<b>ADDRESSEES</b>	: ABC Customer Care and Parts Source Owners and operators of coaches listed under "Application"
<b>VEHICLE TYPE</b>	: CX35
<b>CONFIGURATION GROUP</b>	: 02.46 Engine – Accessory drive systems
<b>BULLETIN TYPE</b>	: Field Change Program
<b>DATE</b>	: November 17th, 2017
<b>SUBJECT</b>	: <b>Removal of crankshaft pull relief device</b>
<b>TERMS &amp; CONDITIONS</b>	: Refer to the warranty section further in this Bulletin.

The Field Change Program, which is subject of this Service Bulletin, applies to CX35 vehicles with a Cummins ISL9 engine and a pull relief device on the engine crankshaft.

**Figure 1: Crankshaft pull relief device design with two springs**

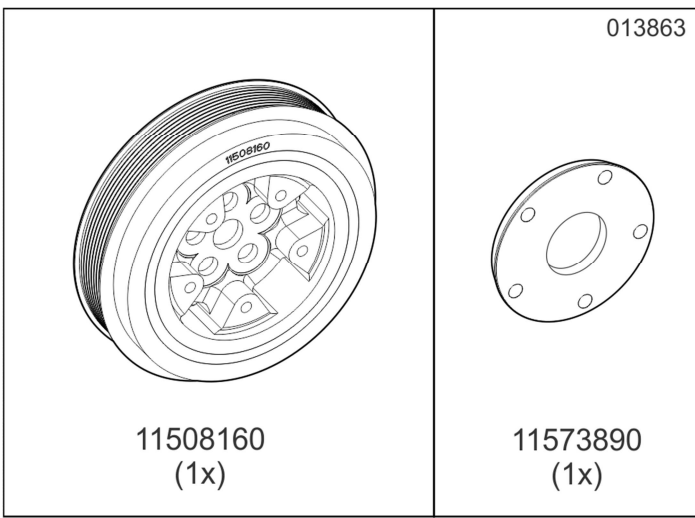
- Van Hool has been informed by Cummins that the pull relief device mounted at the engine crankshaft does not affect the durability of the engine. For that reason, Van Hool is conducting a field change program to remove this crankshaft pull relief device.
- Two crankshaft pull relief designs have been installed during production of these vehicles: a two spring design (refer to figure 1) and a one spring/tie rod design (refer to figure 2). The removal procedure is identical for both designs.
- Follow the step-by-step instructions in this bulletin to remove this crankshaft pull relief device.

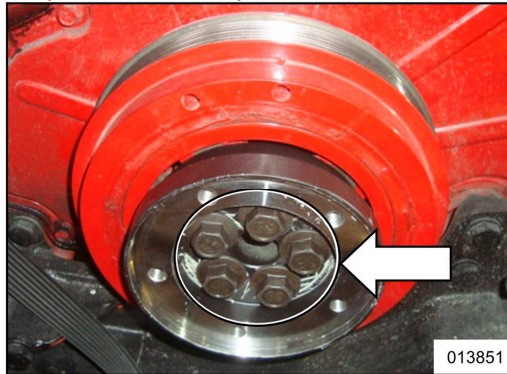
<b>6.1</b>	<p>Remove the five screws and lock washers securing the pull relieve device to the crankshaft. Keep them apart for later use. Take away the pull relief device together with the crankshaft pulley.</p>  <p>013849 <b>Figure 10</b></p>
------------	---
